Access Compliance Report Public Rights-of-Way (Pedestrian Signals)

Main Street: FAIRHAVEN_AVE Cross Street: FAIRHAVEN_AVE Location: NW

ADA ID: SGRK211007112341 Signal Type: One Push Button-Non APS Overall Compliance: No Severity Scores: BTN 1: 35 BTN 2: N/A No BTN: N/A

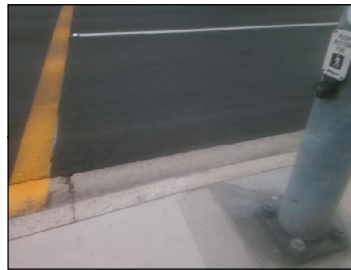
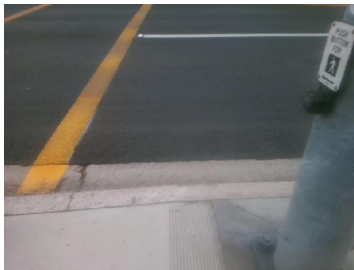
OC Std/PROW: MUTCD 4e.08, R404.2, R404.3

Possible Solutions: Replace Signal Push Button With APS Button. Remove & Relocate Sign.
